May 24, 2018

Add PCD File No. VR-18-014

**FINAL DRAINAGE REPORT FOR
HUNSINGER SUBDIVISION**

HUNSINGER SUBDIVISION EL PASO COUNTY PROPOSED DRAINAGE MAP MAY 2018

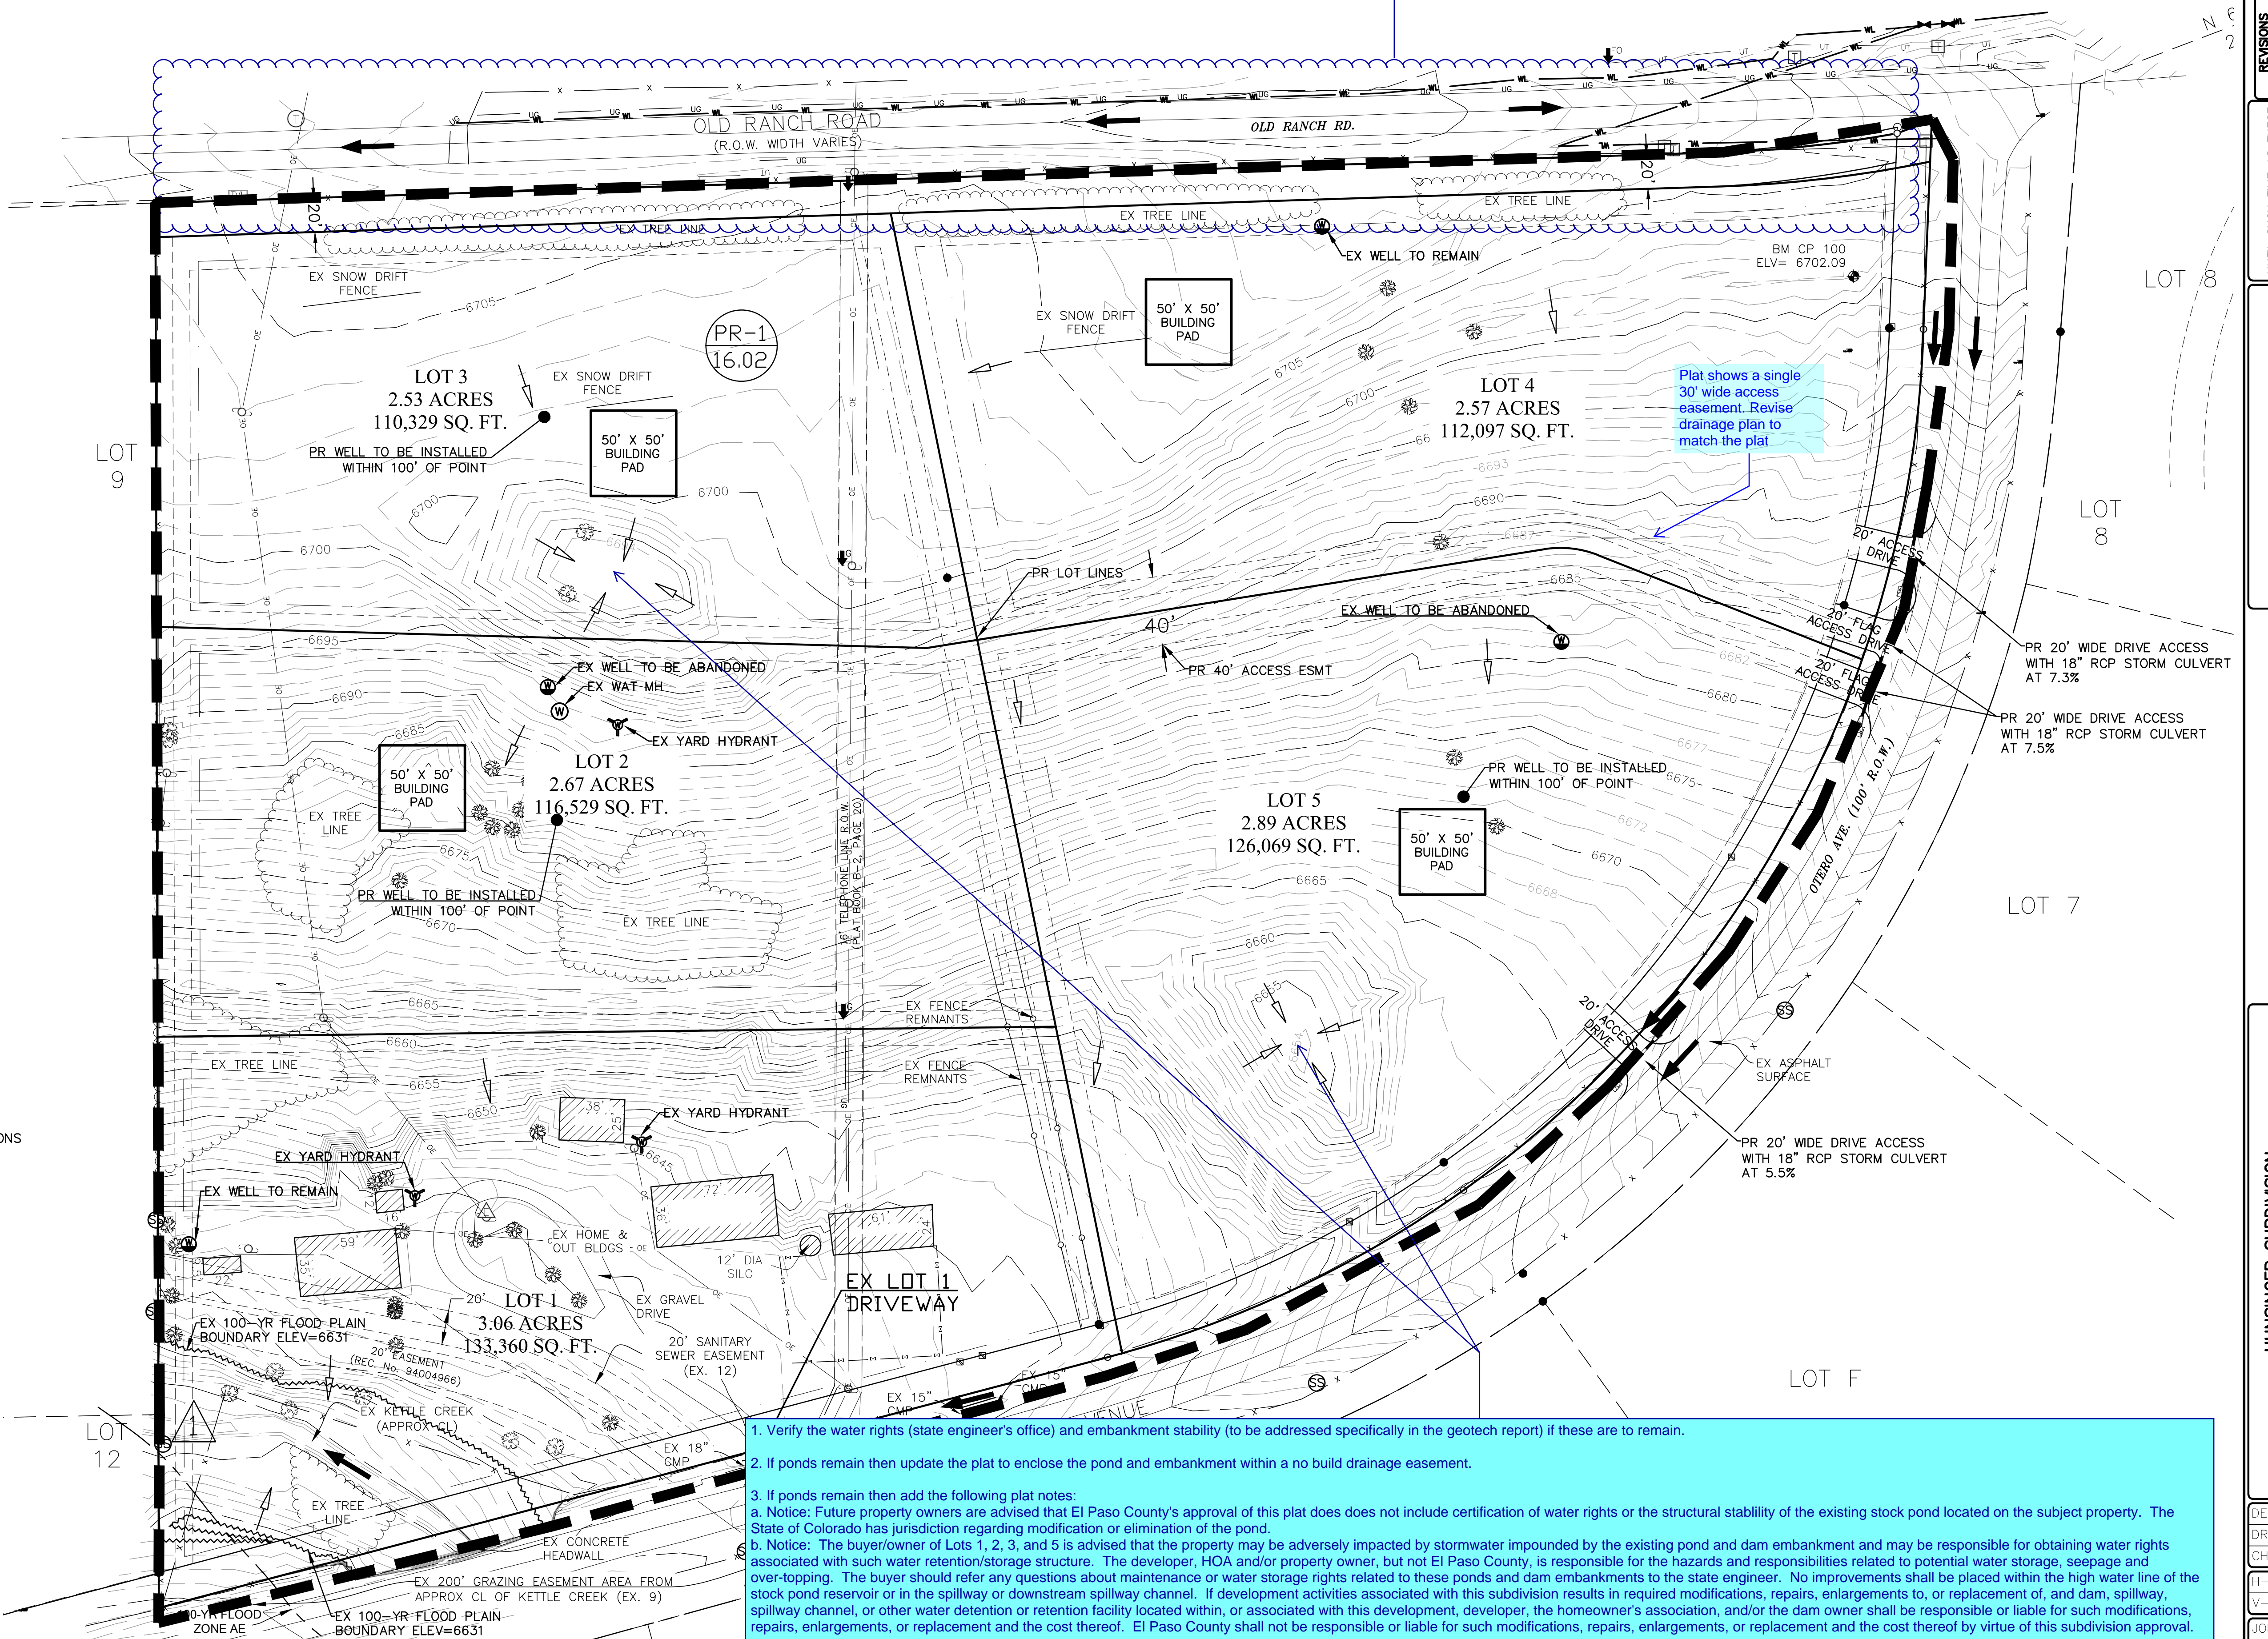
Include the off-site subbasin draining into the property. Update the narrative accordingly.

Plat shows a single 30' wide access easement. Revise drainage plan to match the plat

1. Verify the water rights (state engineer's office) and embankment stability (to be addressed specifically in the geotech report) if these are to remain.

2. If ponds remain then update the plat to enclose the pond and embankment within a no build drainage easement.
 3. If ponds remain then add the following plat notes:

a. Notice: Future property owners are advised that El Paso County's approval of this plat does not include certification of water rights or the structural stability of the existing stock pond located on the subject property. The State of Colorado has jurisdiction regarding modification or elimination of the pond.

b. Notice: The buyer/owner of Lots 1, 2, 3, and 5 is advised that the property may be adversely impacted by stormwater impounded by the existing pond and dam embankment and may be responsible for obtaining water rights associated with such water retention/storage structure. The developer, HOA and/or property owner, but not El Paso County, is responsible for the hazards and responsibilities related to potential water storage, seepage and over-topping. The buyer should refer any questions about maintenance or water storage rights related to these ponds and dam embankments to the state engineer. No improvements shall be placed within the high water line of the stock pond reservoir or in the spillway or downstream spillway channel. If development activities associated with this subdivision results in required modifications, repairs, enlargements to, or replacement of, and dam, spillway, spillway channel, or other water detention or retention facility located within, or associated with this development, developer, the homeowner's association, and/or the dam owner shall be responsible or liable for such modifications, repairs, enlargements, or replacement and the cost thereof. El Paso County shall not be responsible or liable for such modifications, repairs, enlargements, or replacement and the cost thereof by virtue of this subdivision approval.
